<Reference: 97307925-FA>

## **Urgent Field Safety Notice – Product Advisory ACURATE neo2™ and ACURATE Prime™ Aortic Valve Systems (Transcatheter Aortic Valve Implantation (TAVI))**

**Subject:** ACURATE neo2™ Aortic Valve System (TAVI) Instructions for Use and Physician Training Updates, and recommendations for ACURATE Prime™, related to Valve Under Expansion Risk.

## APPENDIX 1 – Updates to ACURATE neo2™ Aortic Valve System Instructions for Use (IFU)

**Figure 1: ACURATE valve under fluoroscopy - valve under expansion is recognized as a non-parallel Commissure Post**

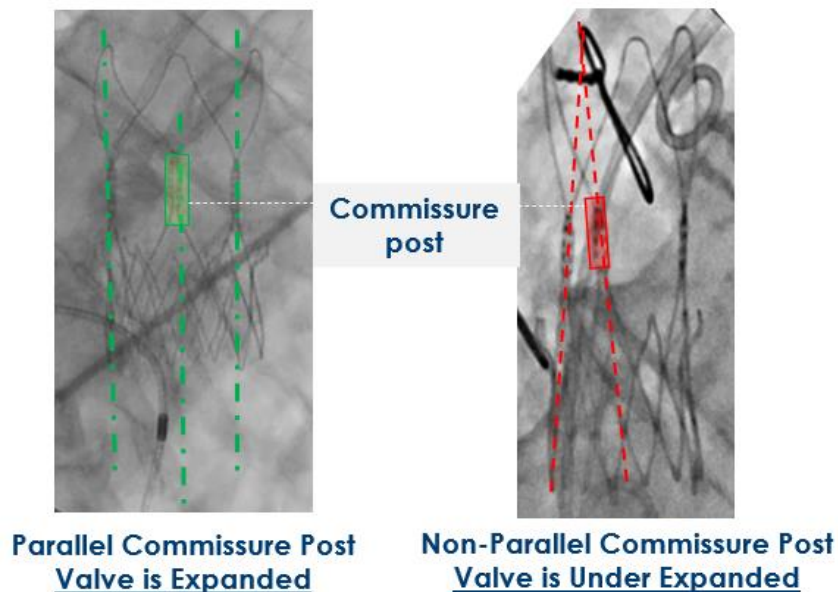
Valve under expansion can be seen under fluoroscopy (as shown in **Figure 1**) during the index procedure and mitigated with appropriate pre-dilation and post-dilation practices. Therefore, Boston Scientific has updated the ACURATE *neo2* IFUs for the risk of valve under expansion and the practices that may reduce this risk, as follows:

- Increased emphasis on pre-dilation with an appropriately sized valvuloplasty balloon.
- Use of a second fluoroscopy view during the procedure to recognize non-parallel commissure posts and under expansion.
- Post-dilation, in accordance with IFU, to improve valve under expansion.

| <b>Delivery System and Loading Kit IFU(s)</b>  |  |
|--|--|
| <p><b>Precautions During Use:</b> The implant procedure should be conducted under fluoroscopic guidance.</p>   | <p><b>Precautions During Use:</b> The implant procedure should be conducted under fluoroscopic guidance. <a href="#">The correct fluoroscopy projection for implantation of the Valve is when all three (3) native aortic valve cusps are in the same plane. After final deployment of the Valve, the use of more than one fluoroscopic projection supports assessment and evaluation of Valve position and expansion.</a></p>   |
| <p><b>Pre-dilation of Native Valve:</b> Prepare the appropriate Balloon Valvuloplasty Catheter (BVC) according to its Instructions For Use</p>   | <p><b>Pre-dilation of Native Valve:</b> Prepare the appropriate Balloon Valvuloplasty Catheter (BVC) according to <a href="#">manufacturer's Instructions For Use</a>. <b>NOTE:</b> <a href="#">It is important to correctly size the BVC for effective pre-dilation. Effective pre-dilation can help reduce the need for post-dilation.</a></p>   |
| <p><b>Verification of Valve Position and Post-Implant Monitoring:</b> Leaving the guidewire in position across the Valve, measure both invasive and non-invasive hemodynamic parameters to check positioning and function of the Valve. Perform an angiogram to evaluate device performance and coronary patency after Valve deployment. The use of echocardiographic imaging supports the assessment of the position of the Valve and an evaluation of the para-valvular and intravalvular leakage. Post-dilation of ACURATE neo2 Aortic Valve is recommended in the presence of significant paravalvular leak.</p> | <p><b>Verification of Valve Position and Post-Implant Monitoring:</b> <a href="#">With pigtail catheter in position across the Valve, measure both invasive and non-invasive hemodynamic parameters to check positioning and function of the Valve. Perform an angiogram to evaluate Valve performance, position, expansion and coronary patency after Valve deployment. The use of echocardiographic imaging supports assessment and evaluation of Valve function, including paravalvular and intravalvular leakage. The use of a second fluoroscopy projection supports assessment and evaluation of Valve expansion.</a> Post-dilation of ACURATE neo2 Aortic Valve is recommended in the presence of valve under-expansion and significant valve dysfunction (paravalvular leak, elevated gradient).</p> |
